CONSENTED SCHEME 2009/4910 - NORTH ELEVATION EXISTING

HHH1/A/306 rev C

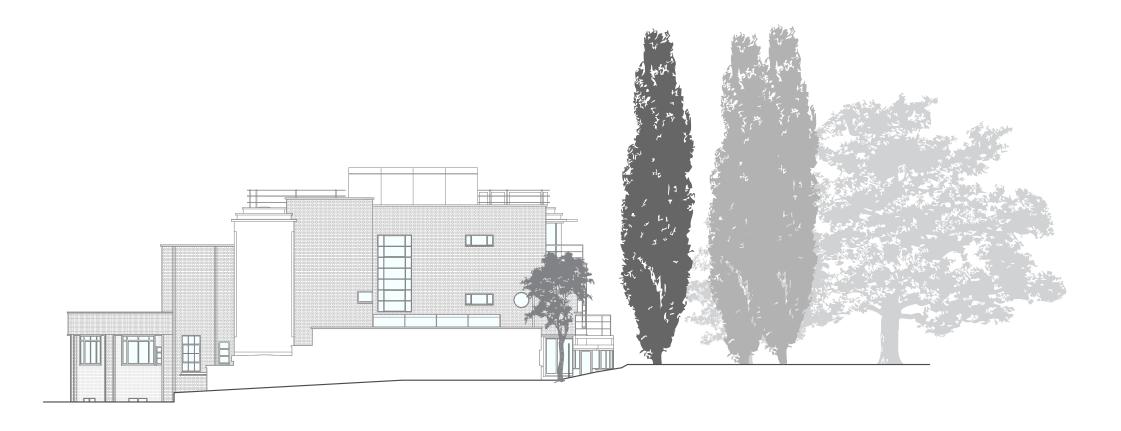
### Rev C - 161109

Materials to entrance of car park indicated.

Rev B - 091009

Dining room reduced north by 500 mm.

#### Rev A

Non-accessible low level planter added to south of annex.

1.2m glazed screens added to prevent access and overlooking.

1/3 of library window specified obscured glass and non-openable.

Planters and guarding added to roof of annex at rear.
